Addendum # 2

Bid Opportunity: 24-7517-RFT - Elmira District Secondary School Special Education and HVAC Upgrades

RE: Elmira District Secondary School - Renovations
Elmira, ON

ADDENDUM 02

Drawing A201 Partial Renovation Plans

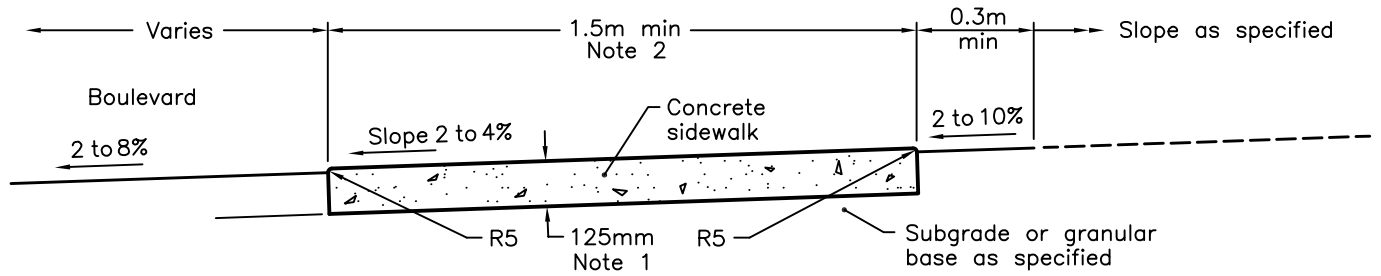
1. Add drawing note #66 at window on gridline 32G, to read “Install aluminum louvre as per mechanical drawings. Finish louvre with continuous aluminum clip on all sides to cover any remaining gaps between existing window frame and louvre, c/w backer rod and sealant. Louvre to have pre-finished aluminum sill flashing, by louvre manufacturer.”

OPSD 310.010

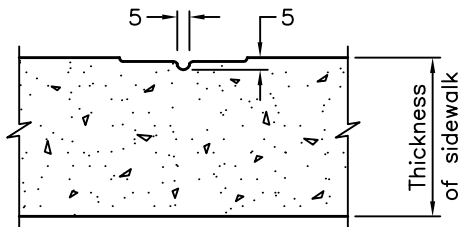
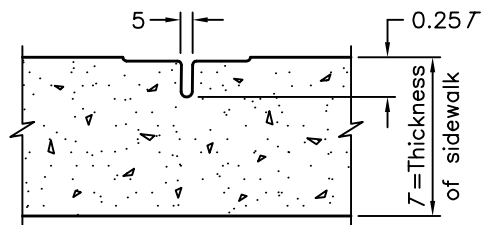
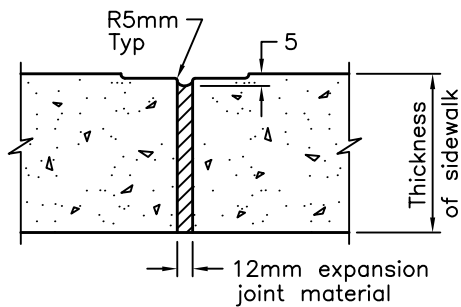
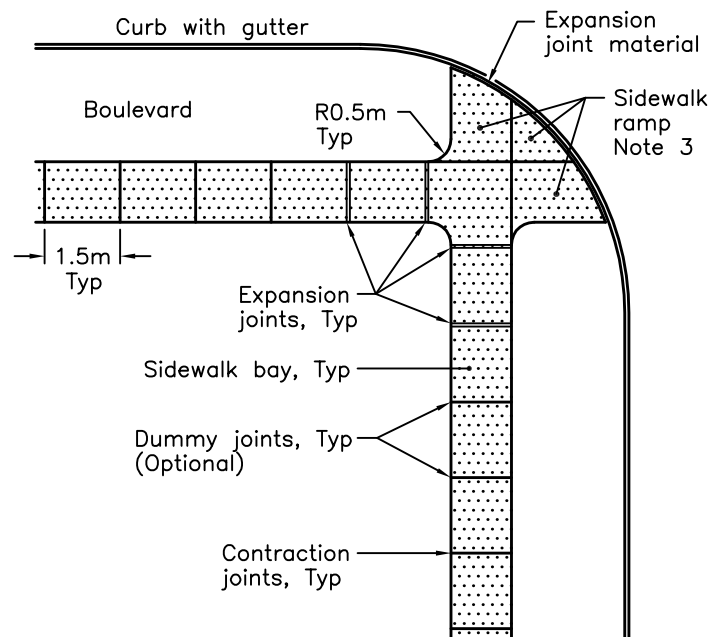
Is the new exterior concrete slab on grade and sidewalks to be reinforced with rebar? I do not see any detail; please advice.

Please follow Concrete specifications noted in Civil drawings and attached OPSD 310.010 detail.

GROUND FLOOR RENOVATION PART PLAN 'C' - DUCTWORK

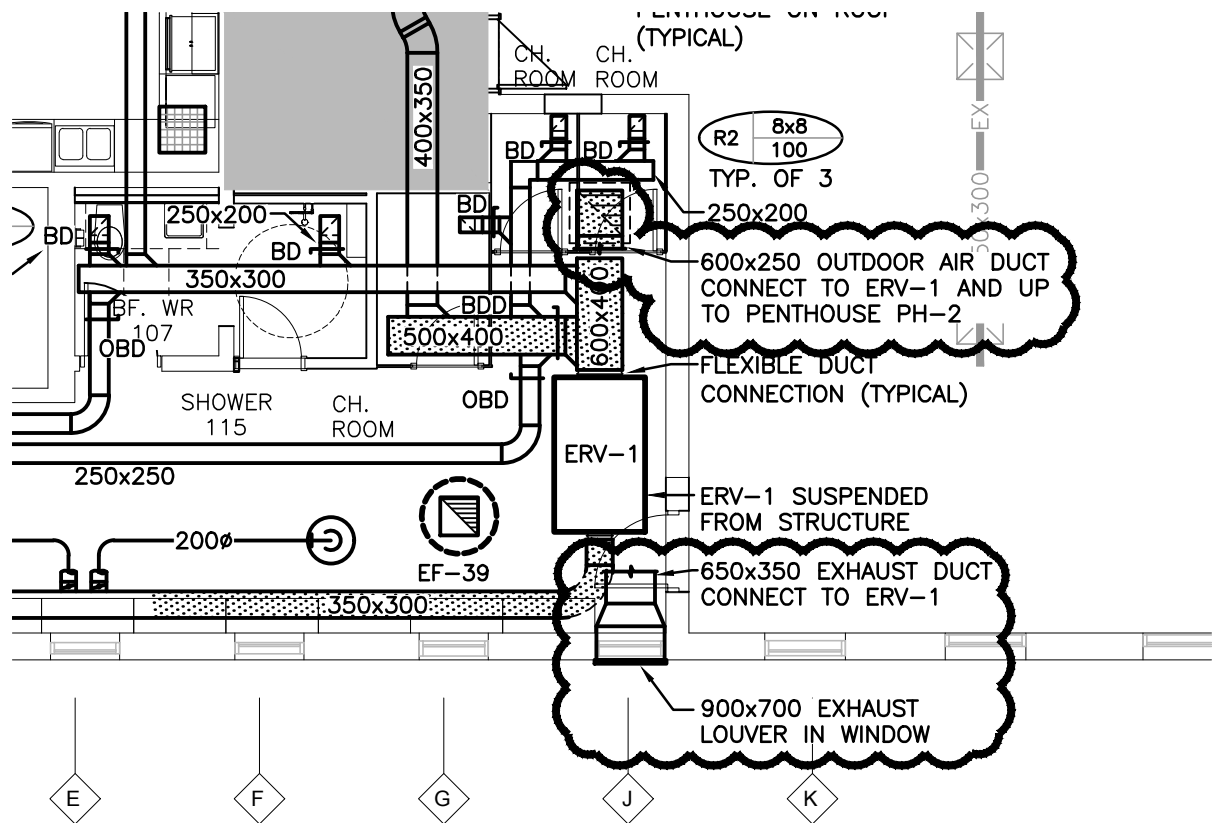
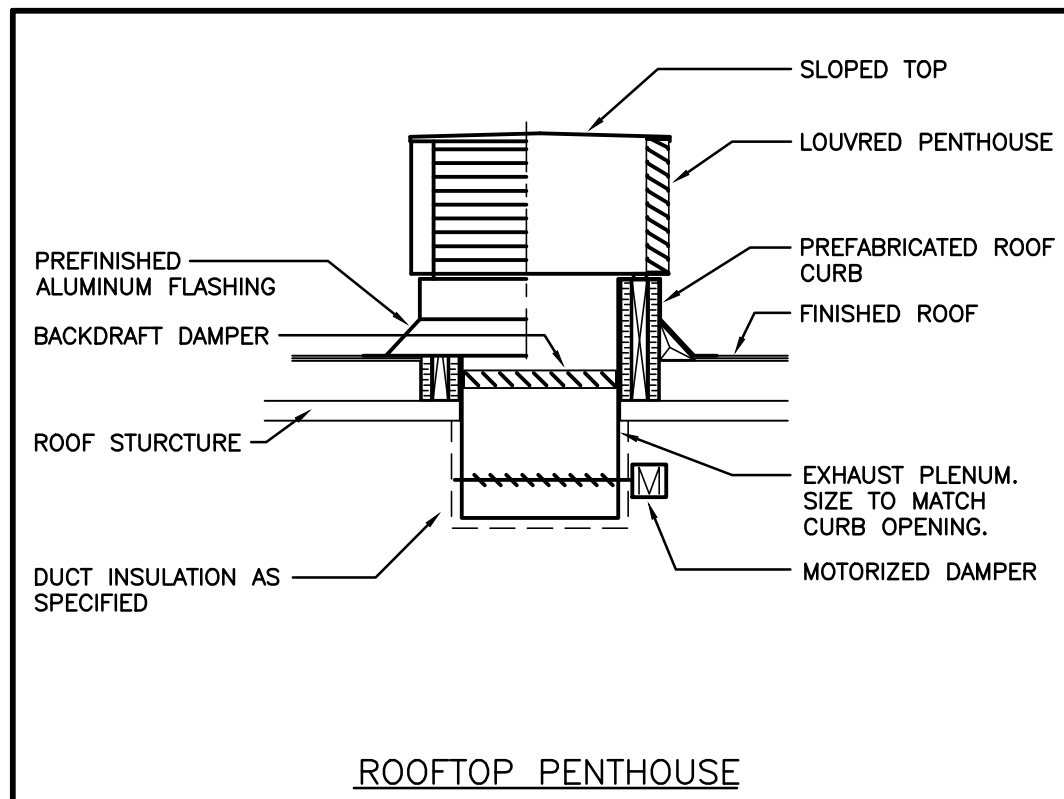
- 2.0 Reference Drawing M207 and Attached Sketch AD02-M01
- .1 In Teams Room 2 106, refer to attached sketch AD02-M01 for intake penthouse (PH-2) and exhaust ductwork for ERV-1.

- 4.0 Reference Drawing M302 and M403 and Attached Sketch AD02-M01
- .1 Provide PH-2 on roof plan. Refer to attached sketch AD02-M01 for location.
 - .2 Refer to attached sketch AD02-M01 for "Rooftop Penthouse" Detail.

Refer to Drawing S203

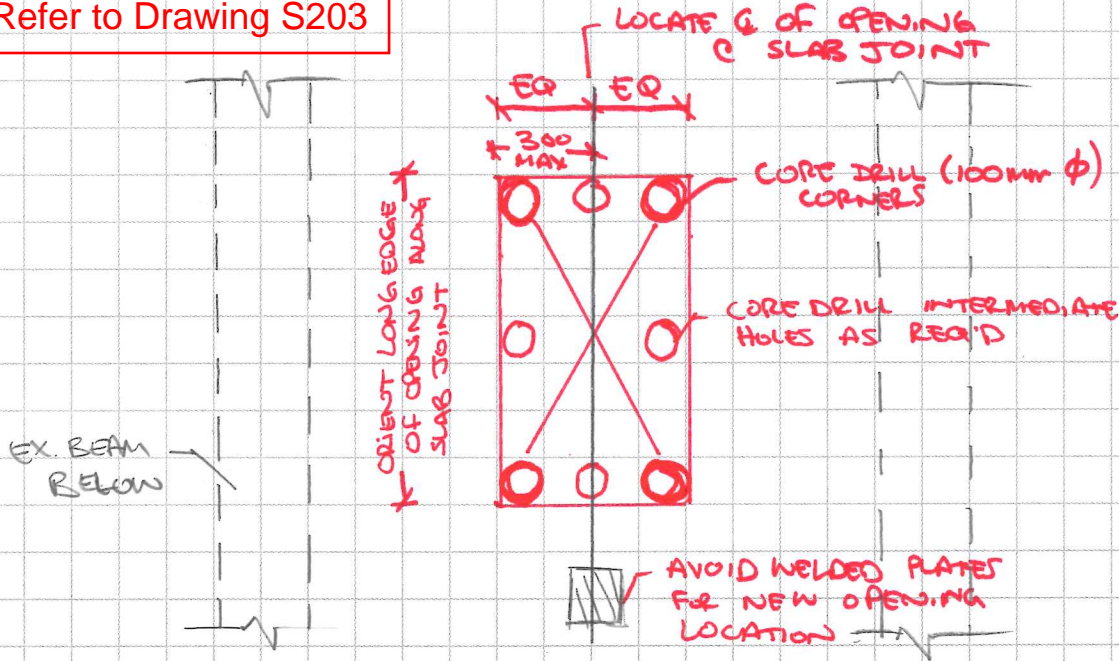
1. For roof penetrations in the concrete T-beams, locate long edge of opening along slab joint. Centre opening with slab joint, max. 600mm wide. Do not overcut openings, provide 100mm core holes in each corner and sawcut opening edge to cored hole. Review roof area to ensure opening is not located over any slab-to-slab connection points. See attached detail for clarity.

- NOTES:
- SAWCUT OPENING TO CORNER HOLES
 - DO NOT OVERCUT OPENING
 - ORIENT LONG EDGE WITH SLAB JOINT
 - DO NOT REMOVE STEEL CONNECTION PLATES.
 - MAKE GOOD EDGES AS REQ'D
